HEARING ON APPEAL UNDER THE BUILDING CODE OF UDELL BRAMSON
AT 349 CUMBERLAND AVENUE, PORTLAND, MAINE.

Subject: Action relating to Building Code appeal
at 543 Cumberland Avenue and unlawful use of the
building as a tenement house

Subject: Application for building permit to cover alterations of the dwelling at 343 Cumberland Avenue and conversion to tenement house.

Check of application for permit and plans attached thereto shows features either not indicated or in non-compliance with Building Code. Section and paragraph indications in column on left are references to Building Code sections and paragraphs applying. Plans are to be revised accordingly and fresh blueprints filed. Other than blueprints or similar copies or blueprints with information on them not printed from the original are not acceptable.

2nd Floor

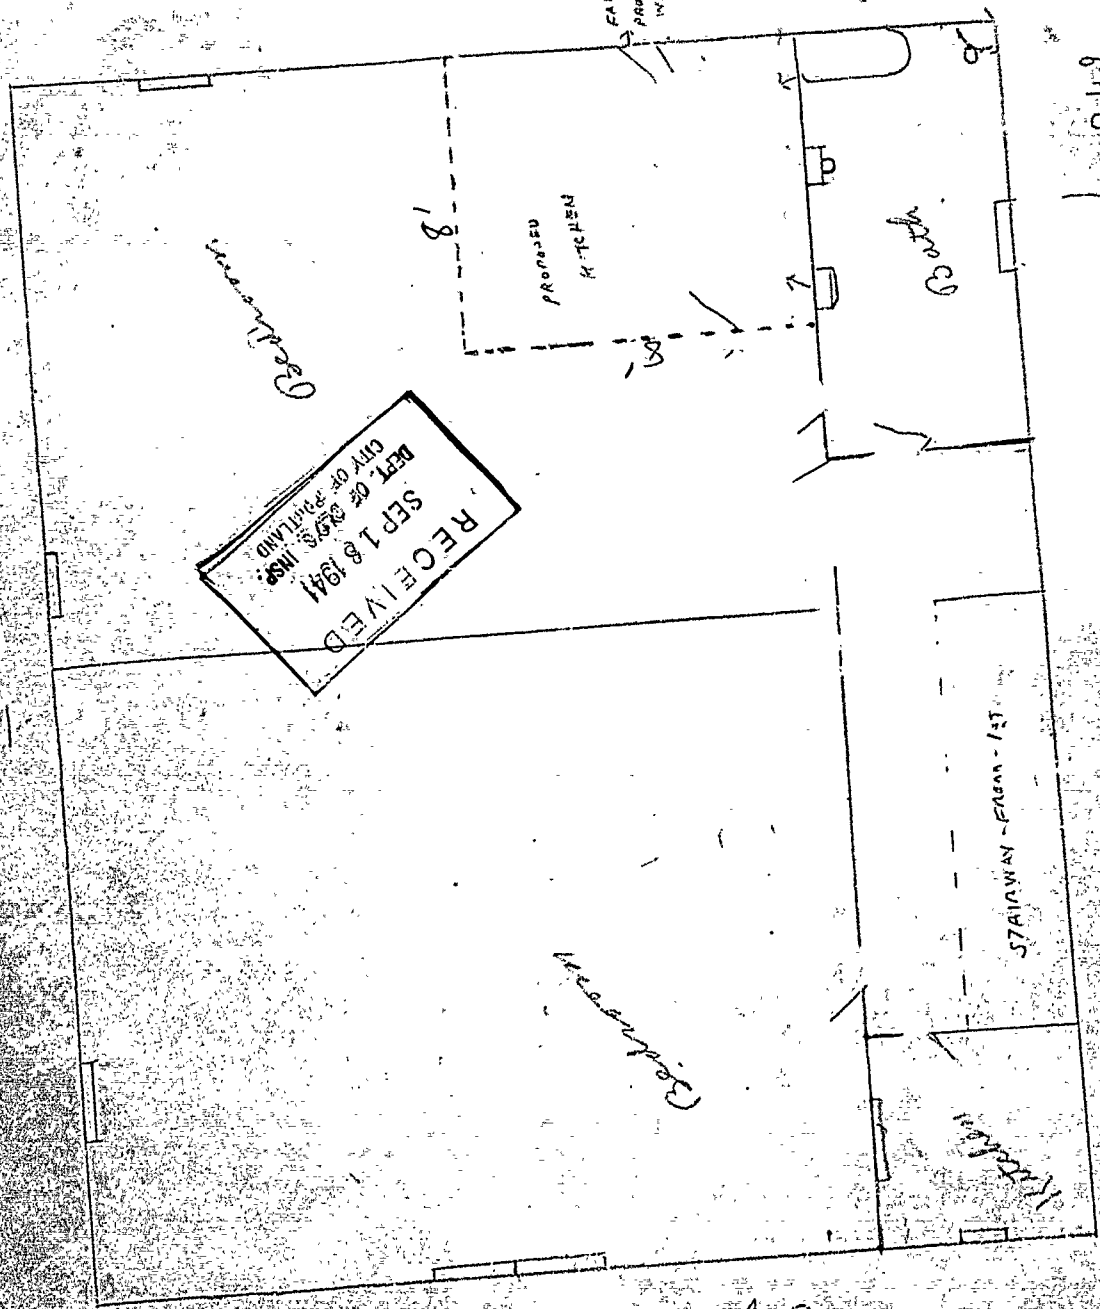
The revised application for a building permit to cover minor changes in your building at 343 Cumberland Avenue still indicates the proposed conversion from a single family dwelling house to a three apartment tenement house with one apartment in the first story and two apartments in the second story.

The new sketch of second floor filed here on October 4, 1941, is far short of the requirements of supplying architectural plans of the entire building to show all of the proposed arrangements in a manner that may be checked against Building Code requirements.

As explained to Mr. Ryan on September 1st, however, there is enough information on the sketch which he left here to show that there would be only one means of egress to the ground out-of-doors from the two apartments on the second floor which is contrary to the Building Code.
